JAMES A. FITZPATRICK NUCLEAR POWER PLANT

AMENDMENT TO FACILITY OPERATING LICENSE

Amendment No. 117  
License No. DPR-59

SAFETY EVALUATION BY THE OFFICE OF NUCLEAR REACTOR REGULATION

Figure 3.1-2

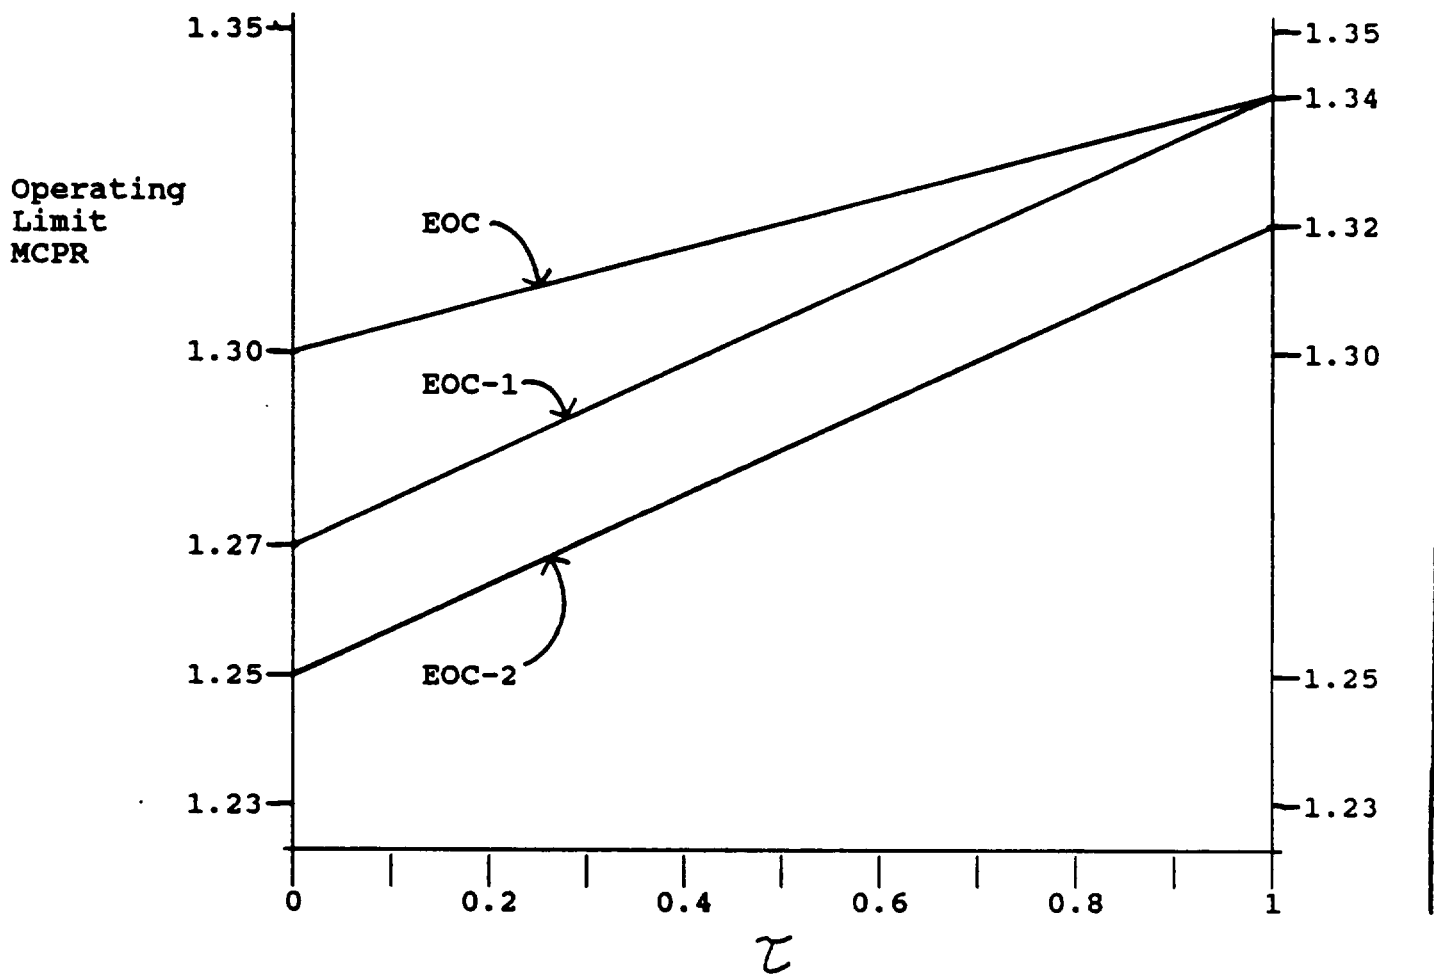
2. If requirement 4.1.E.1 is not met (i.e.  $\tau_B < \tau_{AVE}$ ) then the Operating Limit M CPR values (as a function of  $\tau$ ) is as given in Figure 3.1-2.

To assure that the fuel cladding integrity safety limit MCPR will not be violated during any anticipated transient, the most limiting events were reanalyzed for this reload (Ref. 1) to determine which events result in the largest reduction in CPR. The operating limit MCPR was then established by adding the largest reduction factor in the CPR to the safety limit MCPR. Since acceptable methods (Ref. 3) have been used, we find the MCPR Technical Specification changes to be acceptable.

Figure 3.5-13

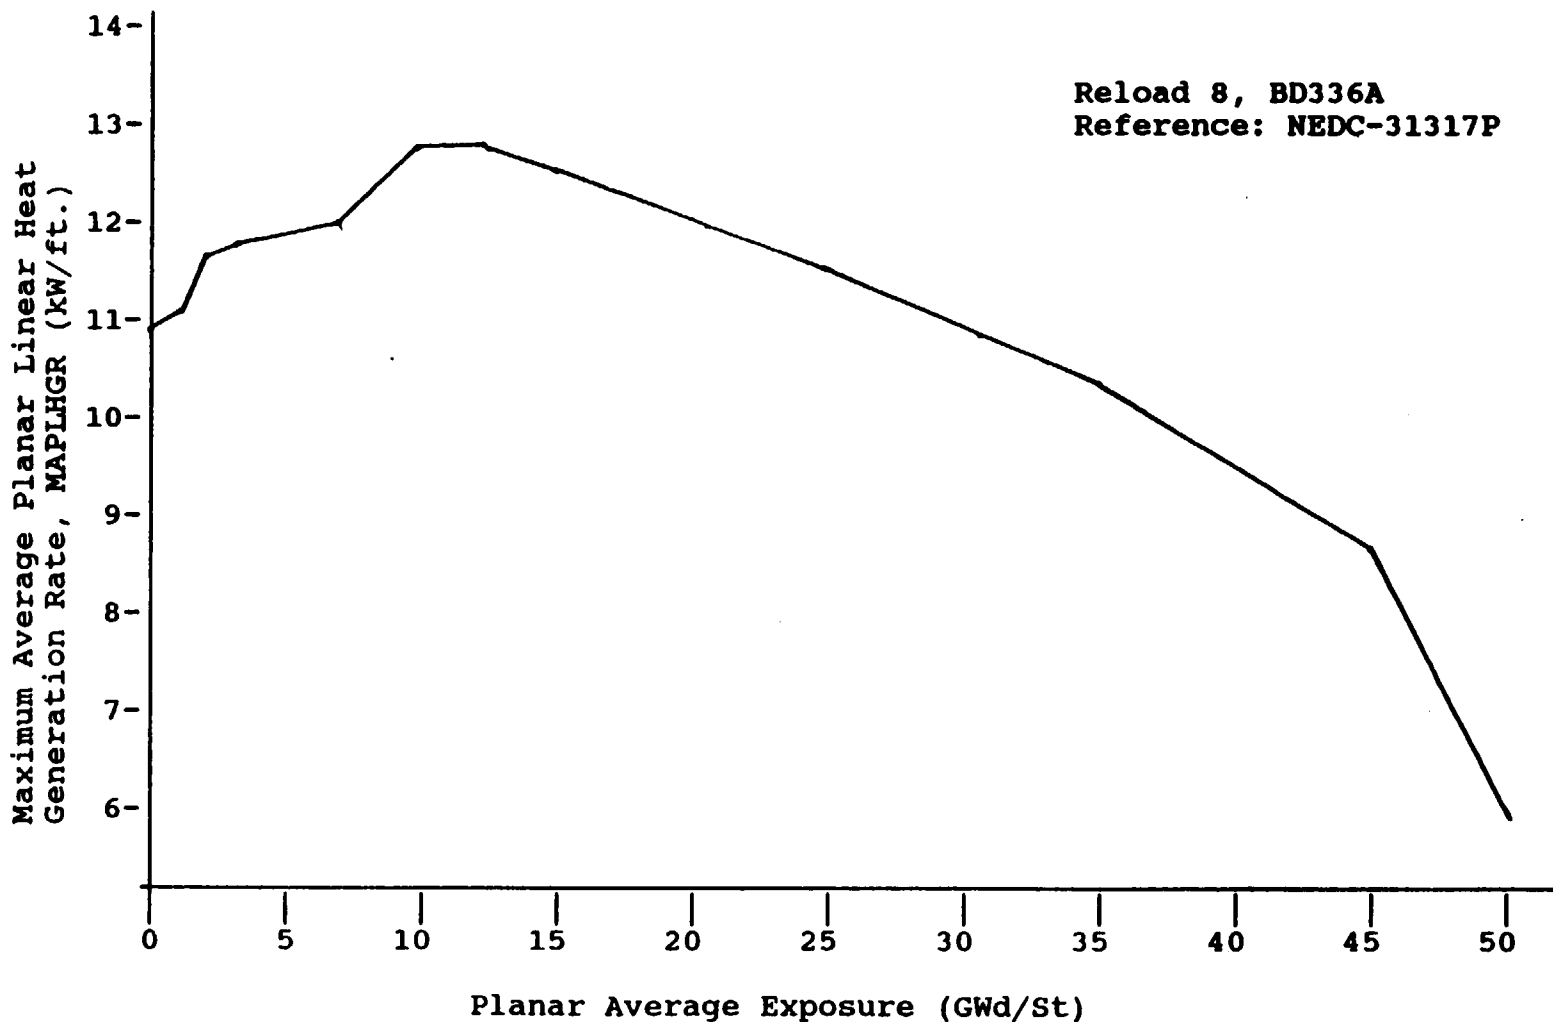
are within the 10 CFR 50 Appendix K limit. The limiting values for APLHGR are given in Figures 3.5-11 through 3.5-14. Approved limiting values of APLHGR as a function of fuel type are given in NEDO-21662-2 (as amended) for Reload 6 fuel. Approved limiting values of APLHGR as a function of fuel and lattice types are given in NEDC-31317P (as amended) for Reload 7 and 8 fuel. These values are multiplied by 0.84 during Single Loop Operation. The derivation of this multiplier can be found in Bases 3.5.K, Reference 1.

The Maximum Average Planar Linear Heat Generation Rate (MAPLHGR) limits specified in the proposed Technical Specification changes are less than or equal to the bounding MAPLHGR used in the SAFER/GESTR-LOCA analysis (Ref. 3) and are, therefore, acceptable.

For single-loop operation, these MAPLHGR values are multiplied by 0.84.
